# TOWN OF GUILDERLAND

## MEMORANDUM

SUBJ: Albany County Club – 300 Wormer Road  
**Planning Board Sketch Plan Review – Albany Country Club Country Hamlet**

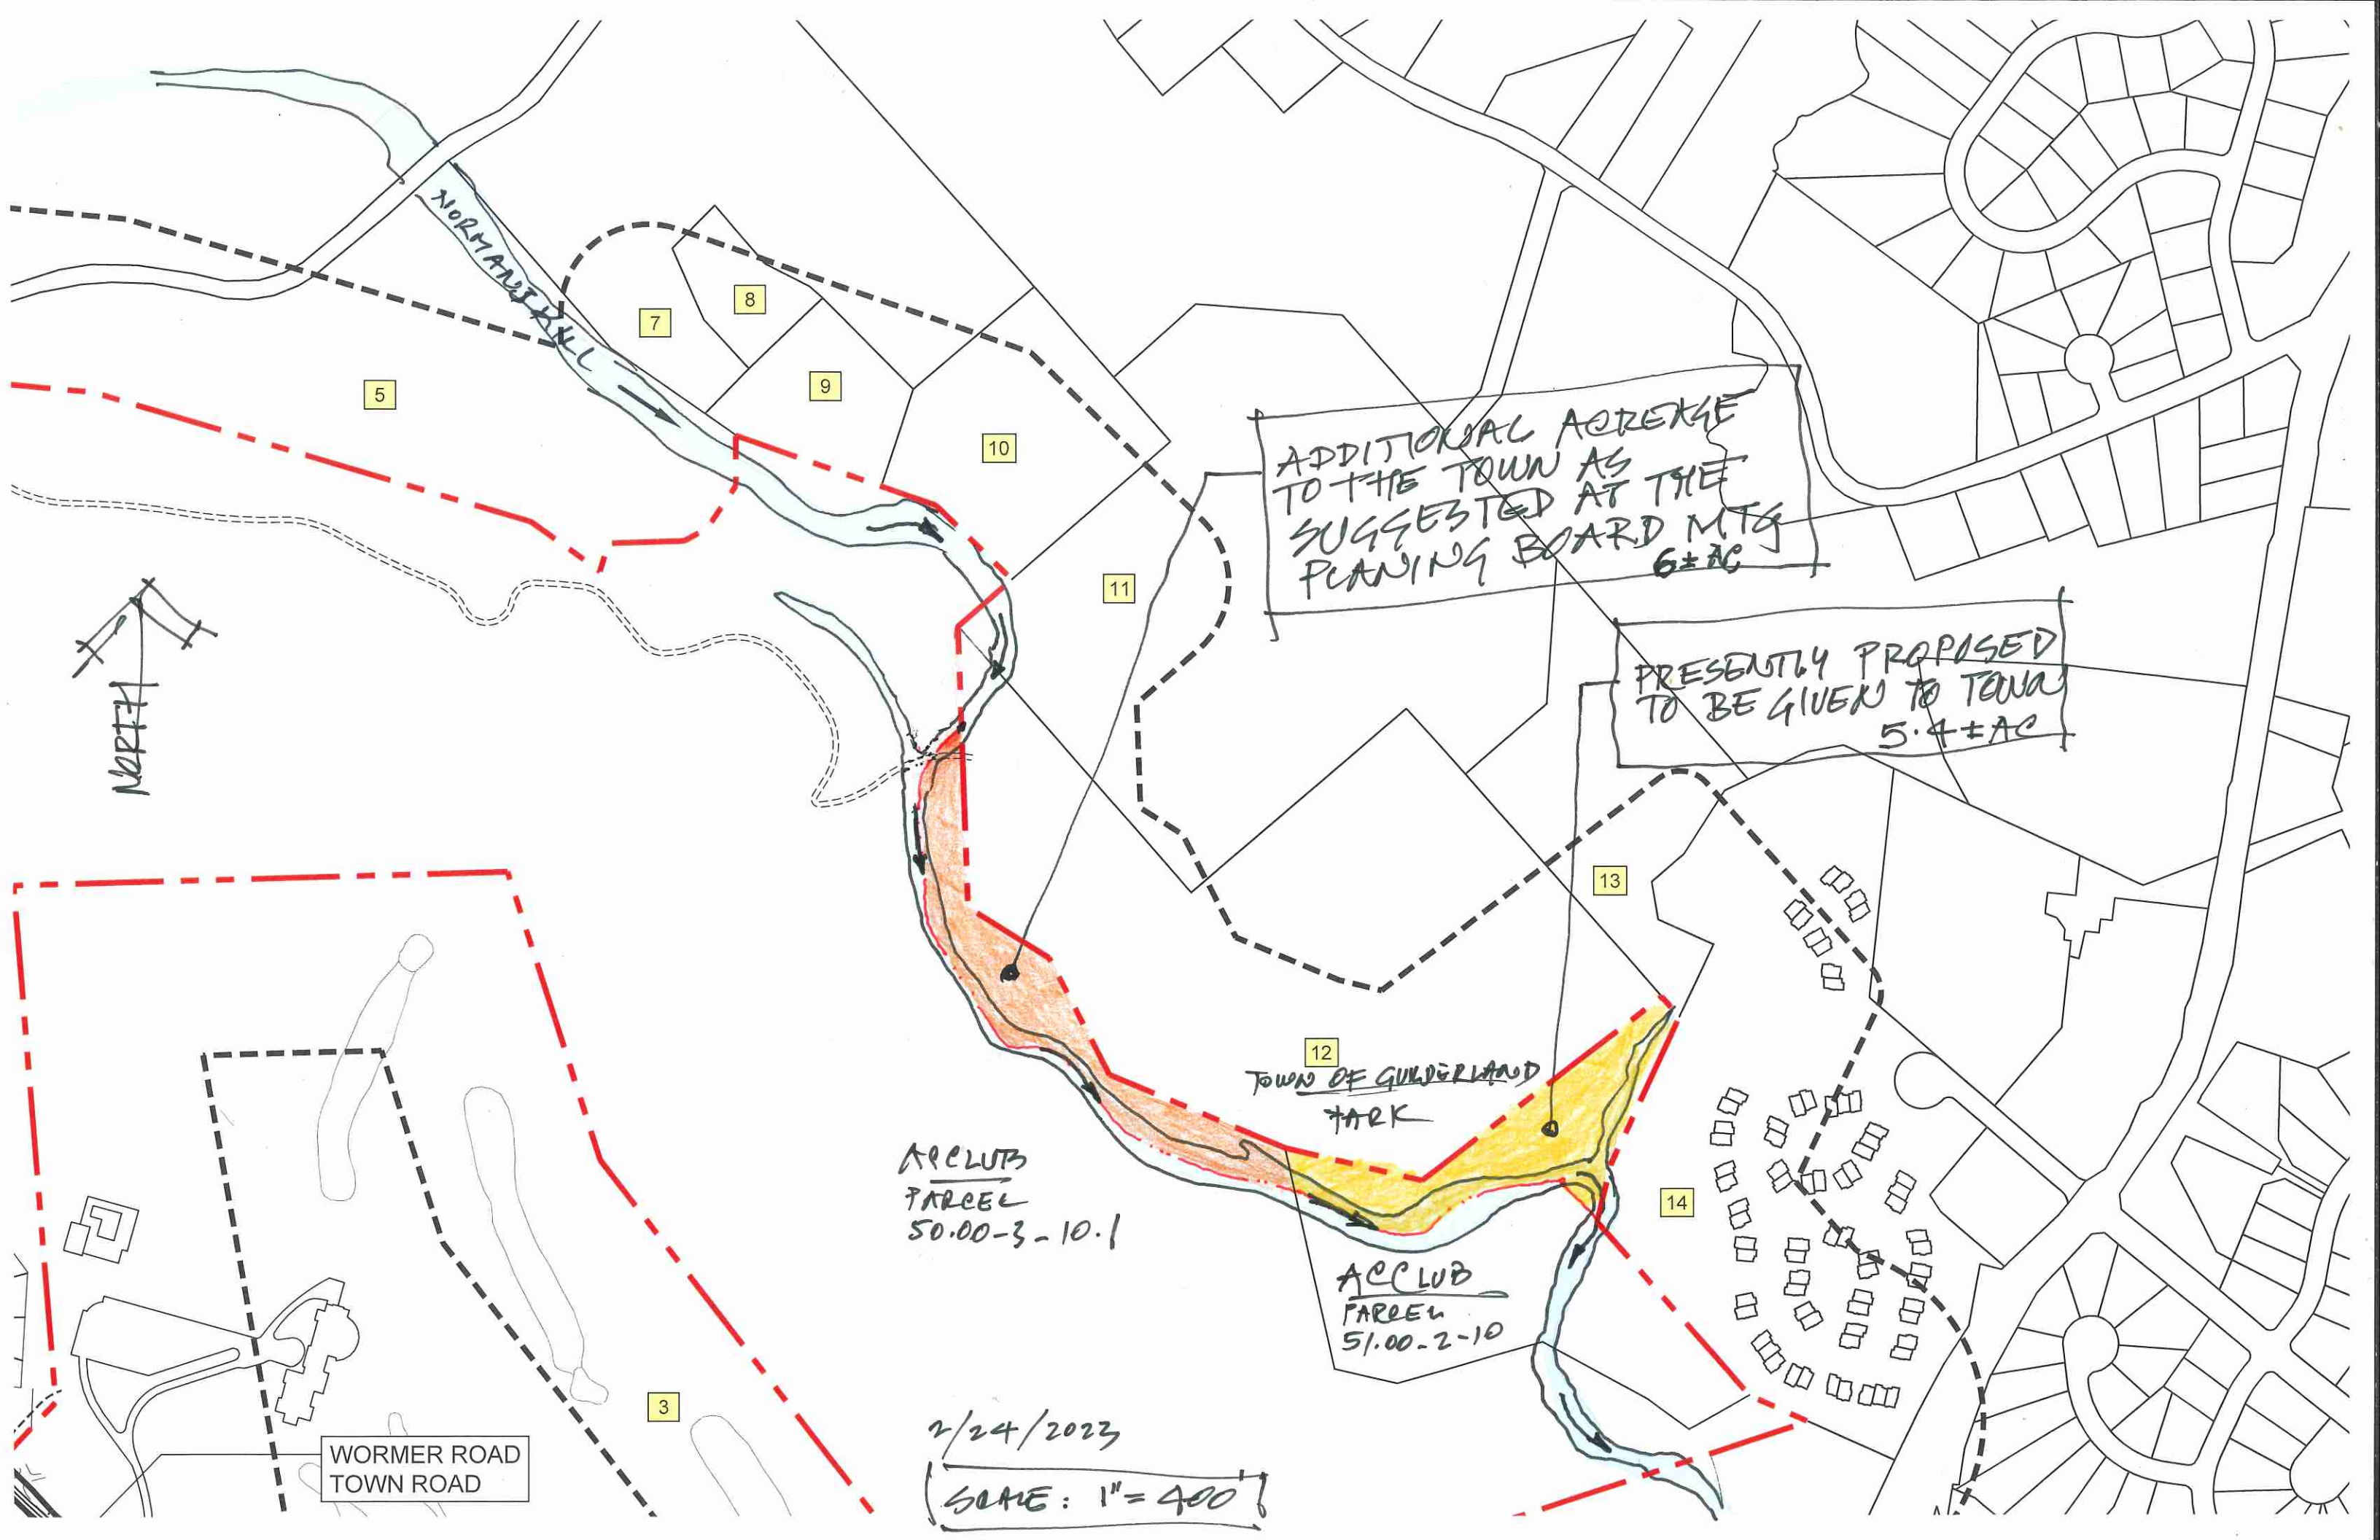
1. The proposed density of 254 units (88 single-family, 116 townhome units and 50 multi-family units) seems to be balanced with the proposed 121 acres of open space to be preserved within the development area and approximately 400 acres outside of the development area. This density should be viewed as the maximum permitted subject to detailed site plan review. The proposed building layout should also be viewed as preliminary and subject to change during site plan review.

2. Open space areas will consist of lands conveyed to the town for town park purposes and deed restricted open space. Pedestrian trails are proposed within open space areas.

4. Pedestrian improvements are proposed for sections of Wormer Road, from NYS Route 155, through the Country Club property to the area of the proposed development. More detailed analysis of the improvements will be reviewed as part of the formal site plan review.

9. A project phasing plan should be identified for both unit build out and for completion milestones of proposed linkages to public infrastructure.
10. In addition to the proposed access points, it would be beneficial for the two adjacent local intersections, Wormer-Grant Hill & Wormer-Relyea, to be reviewed and analyzed as part of the traffic report.

11. The sketch plan identifies 9 access drives onto Wormer Road, recommend exploring a reduction to the amount of access points to what would now become a collector road.

12. The total area of wetland impact should be quantified and indicate if any mitigation areas will be required.

13. Within 5 miles of the project site are documented hibernacula of the Northern Long-Eared Bat. The main impact of concern for the bats is the cutting or removal of potential roost trees. Mitigation measures to avoid impacts should be identified.
